REPORT AMENDED BY STAFF 3-9-89  
**CITY PLANNING COMMISSION**  
 1231 "I" STREET, SUITE 200, SACRAMENTO, CA 95814

- APPLICATION:**
- A. Negative Declaration
  - B. Special Permit to allow a 10 percent density bonus for a 52 unit apartment complex on 2.23+ vacant acres in the Multi-family (R-2B) zone.
  - C. Lot Line Adjustment to merge three lots into one in the R-2B zone.

**LOCATION:** Southwest corner of Ford Street and Norwood Avenue.

**PROPOSAL:** The applicant is requesting the necessary entitlements to construct a 52 unit apartment complex.

SITE PLAN: 1"=30'

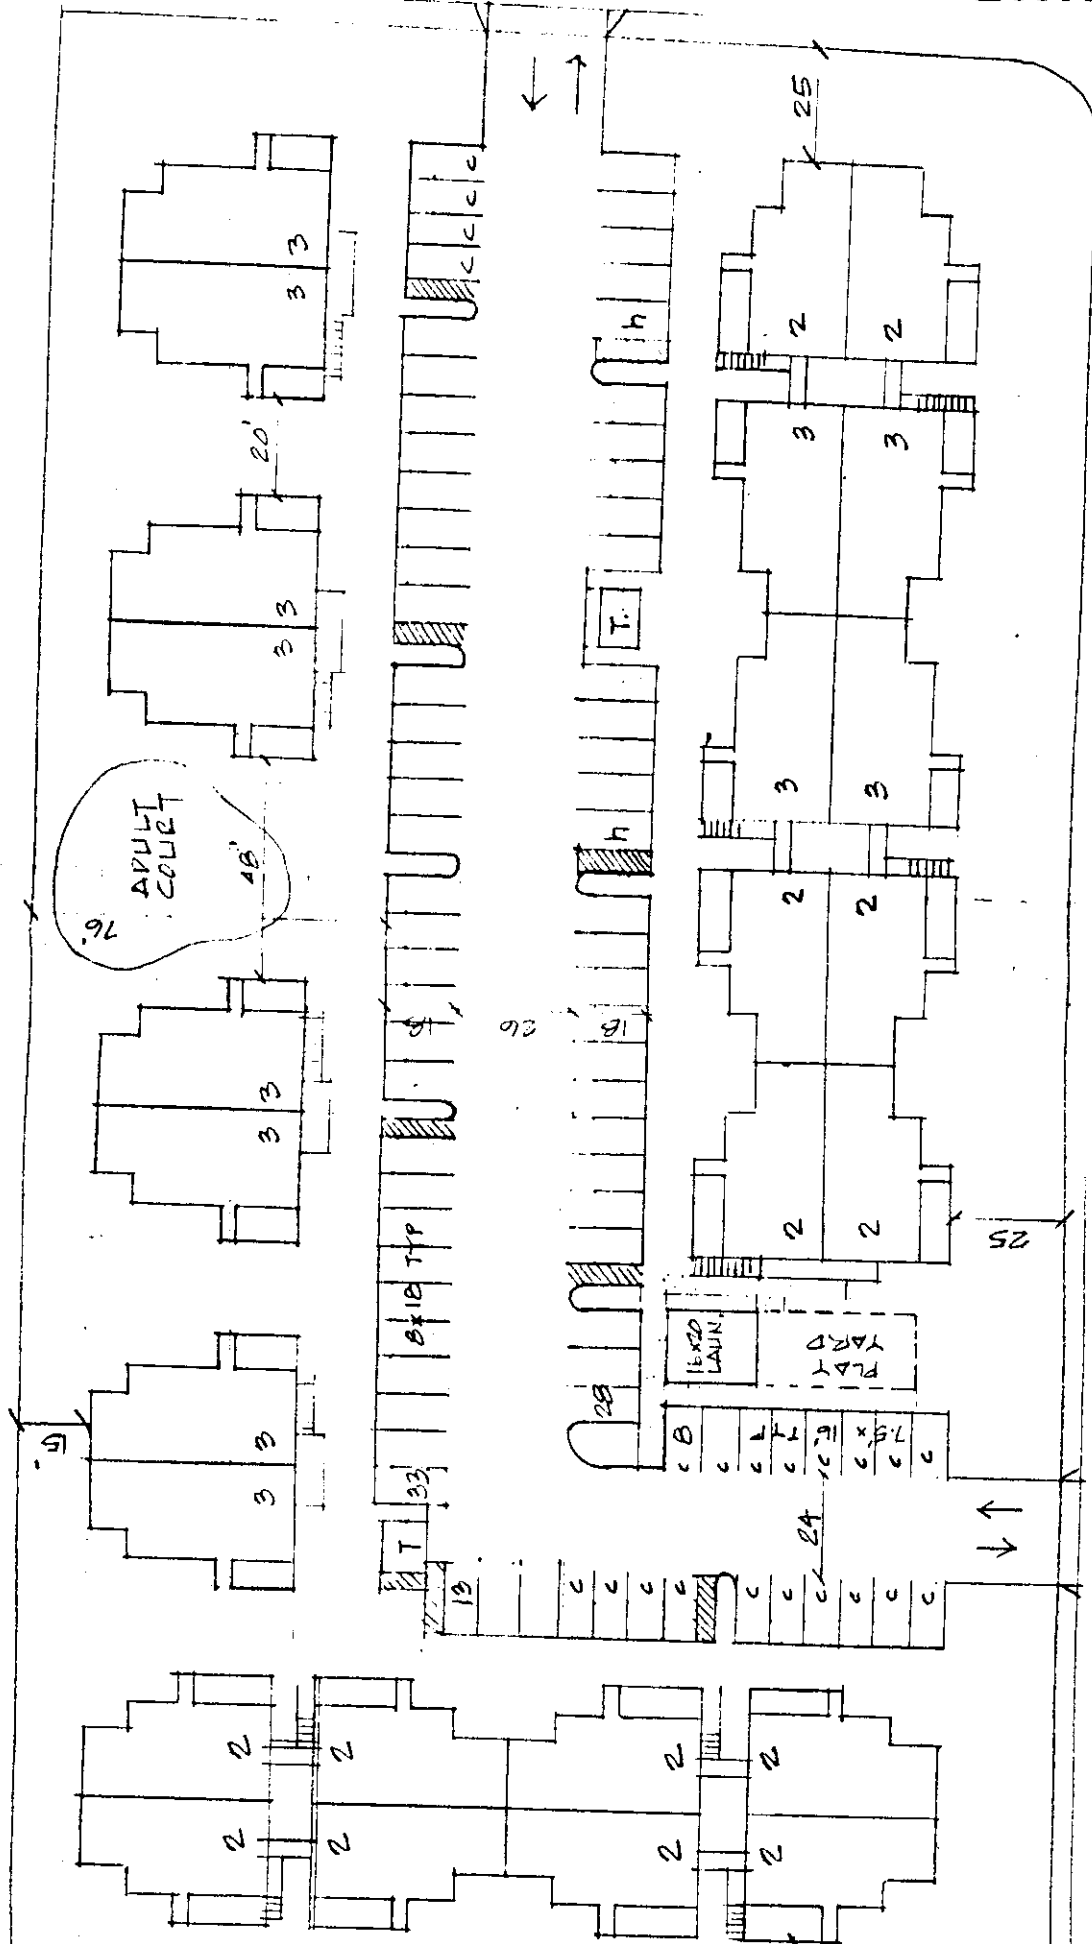
The submitted site plan indicates apartment units on the east, west and south perimeter of the site. A laundry room, play area and an adult court is indicated on the site plan. Two trash enclosures are also identified on the plan. Two driveway entrances and exits are indicated on the site plan off of Norwood Avenue and Ford Avenue. Building configuration has allowed for 82 parking spaces. Parking is located in the center of the lot for direct access to the individual units. Staff recommends that the units be connected to the parking areas by walkways.

The site plan indicates a 25 foot front yard and street side yard setback along Ford Avenue and Norwood Avenue. A 15 foot interior side yard setback and a 15 foot rear yard setback are indicated on the site plan. The applicant has met the minimum required setbacks for the subject site. Staff, however, recommends that the 25 foot front yard and street side yard be landscaped with three and one-half foot high undulating berms with lawn and trees. The applicant has indicated to staff that a six foot high wrought iron fence will be provided along Norwood Avenue and Ford Avenue. Currently, an old wooden fence and a cyclone fence is located on the west property line. Staff recommends that a new six foot high wooden fence be provided along the west

property line to adequately screen the existing single family homes from the proposed apartment units. Trees and shrubs provided along the west property line.

Staff observed a demolished wooden fence on the south property line. Staff recommends that a 6 foot high new wooden fence be provided along the south property line. The applicant has not submitted landscape plans for the subject site. Staff recommends that landscape and irrigation plans be submitted for review and approval prior to issuance of building permits. Landscaping and the maintaining of landscaping is an integral part of a successful infill development.

Two trash enclosures are indicated on the site plan. The trash enclosures shall comply with the City's Trash Enclosure Ordinance.

A total of eighty-two (82) parking spaces are proposed on the site. Under the current Zoning Ordinance, the proposed number of units would only require a total of eight-one (81) parking spaces based on 1.5 spaces per each unit plus one guest space per 15 units. The applicant has, therefore, met the parking requirements for the site. Lighting in the parking area shall be provided and shall be low in height and shielded away from adjacent property. The City's Traffic Engineer had no objections to the proposed vehicle circulation within the subject site. Vehicles can enter and exit off of Norwood Avenue and Ford Avenue.

1. The proposed apartment units shall be connected to the parking areas by walkways.
2. A minimum 25 foot landscape setback shall be provided along Norwood Avenue and Ford Avenue. The landscape setbacks shall consist of lawn material with three and one-half foot undulating berms and trees.

4. A six foot high wooden fence shall be provided along the west property line. One and five gallon shrubs and five and 15 gallon evergreen trees shall be provided along the west property line.

5. The applicant shall provide a six foot high new wooden fence along the south property line.
6. Trash enclosures shall comply with the City's Trash Enclosure Ordinance.

12. The two-way driveway off Norwood Avenue and Ford Road shall conform to the minimum driveway width of 24 feet and maximum width of 35 feet as required by the City Traffic Engineer.

# Exhibit C

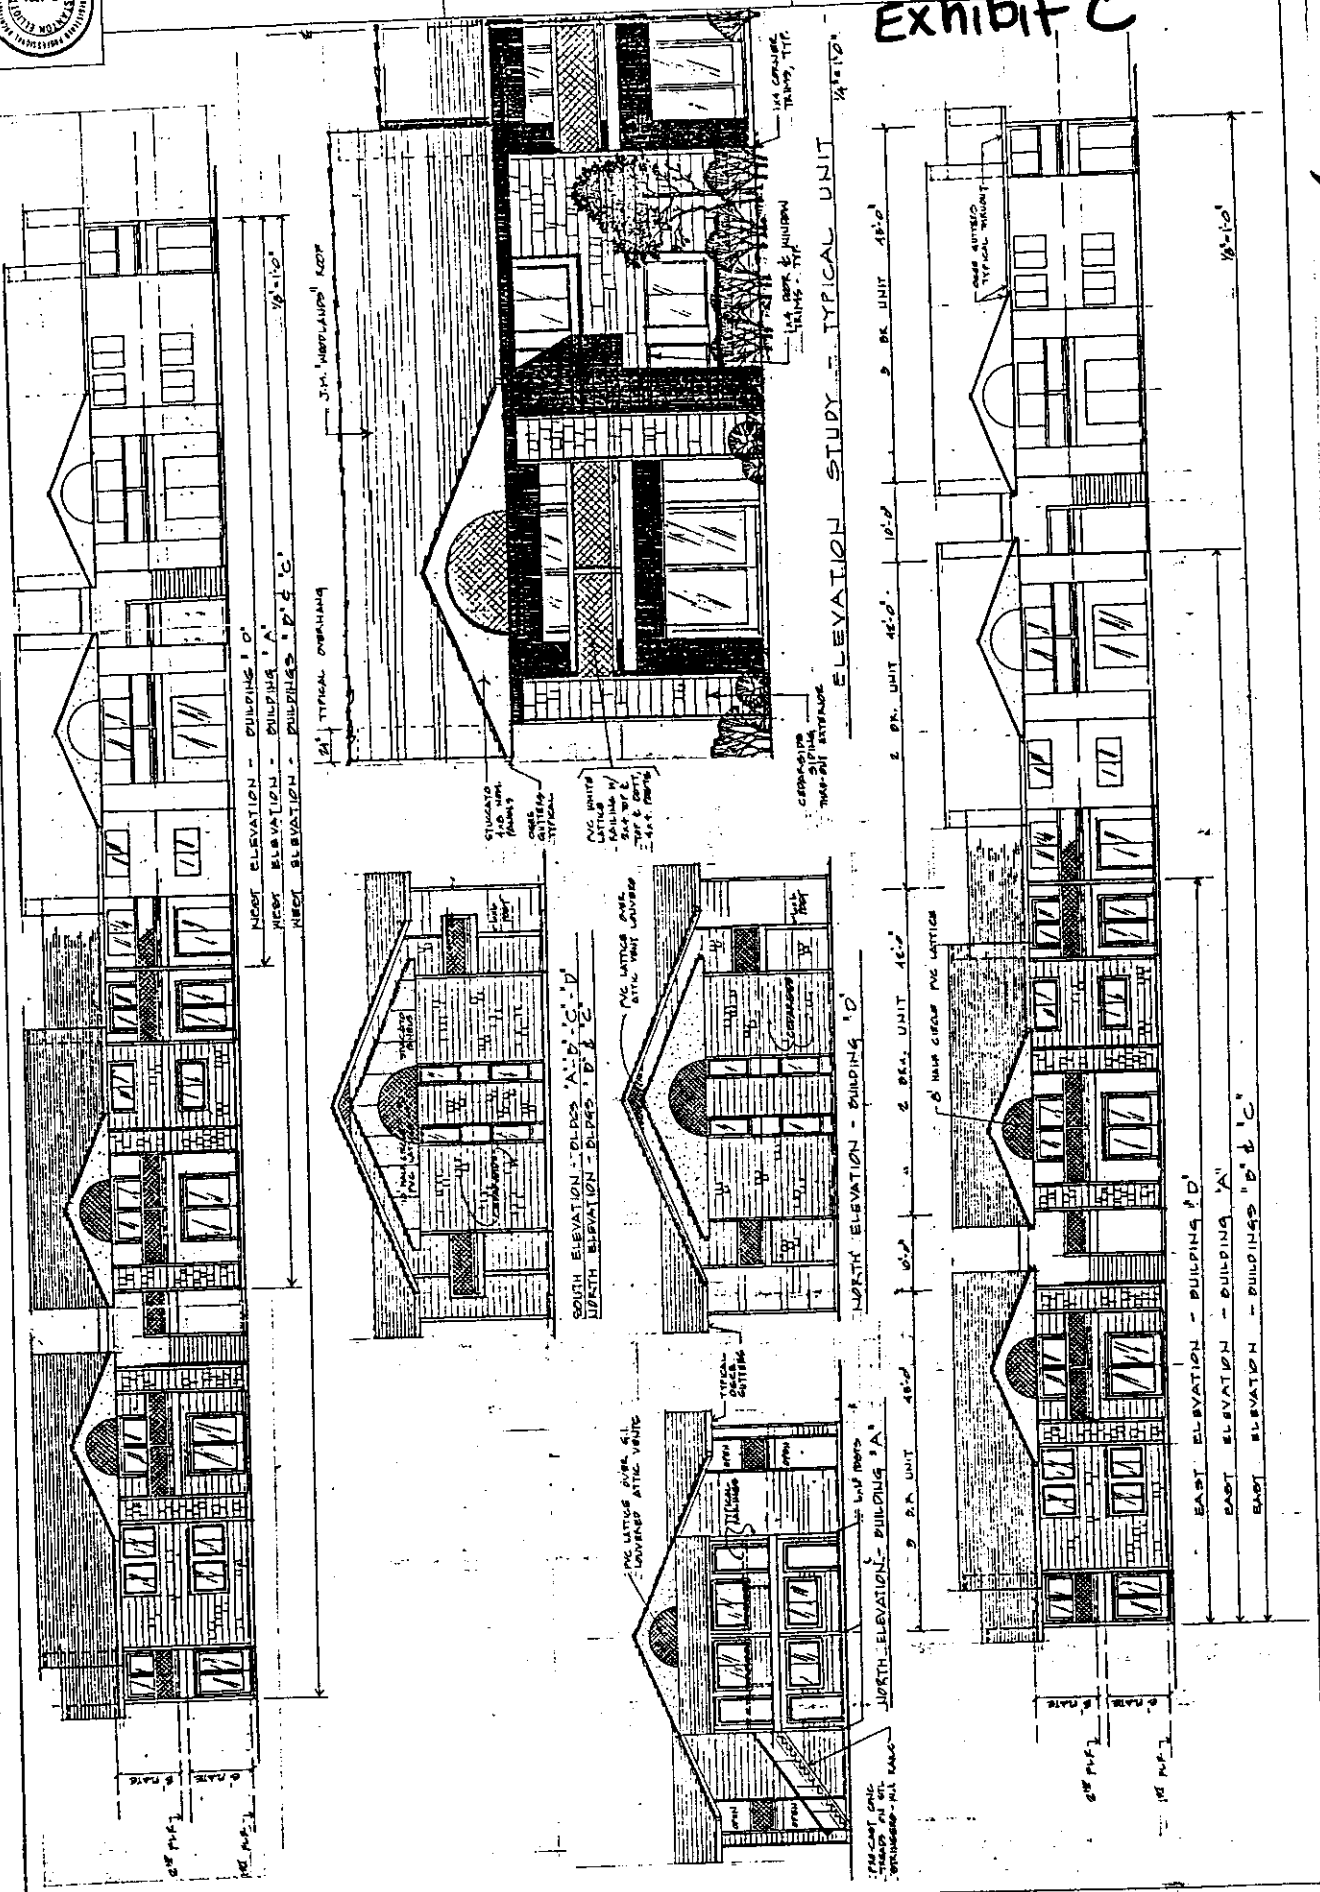
The applicant submitted a site plan and elevations for the proposed apartment units. The site plan indicates 28 two bedroom units and 24 three bedroom units. The proposed apartment building's height is 23 feet. The submitted building elevations were reviewed by the Design Review staff and found to be an acceptable design. The applicant shall submit floor plans for review and approval prior to issuance of building permits. Building orientation was reviewed by staff and minor revisions were suggested. The City, typically, discourages second floor units overlooking into single-family home lots. In this instance, staff recommended that the unit's patio on the west property line be oriented to not face the single family homes. The applicant has agreed with staff on this revision and a solid wall will face the single family lots. This reorientation of the units will allow privacy for the existing single family homes.

The project is tentatively scheduled to go before the Design Review and Preservation Board for review on April 5, 1989. At this time, additional conditions regarding the design, material and color may be recommended. Screening of all mechanical equipment (including public utility boxes and wall mounted air conditioning units) shall be attractively screened either through landscaping or fencing. Trellis will be used in place of the balusters

10. The apartment unit patios located on the west property line shall not be oriented towards the existing single family homes.
11. The applicant shall construct Norwood Avenue to a 40 foot halfsection with standard improvements and Ford Avenue to a 27 foot halfsection with standard improvements to match existing as required by the City Traffic Engineer. These frontage improvements shall be required at time of building permit issuance.

16. The project shall be subject to review and approval by the Design Review/Preservation Board.
17. The completed project shall be inspected by the Planning Director prior to approval of the final inspection by the Building Division.
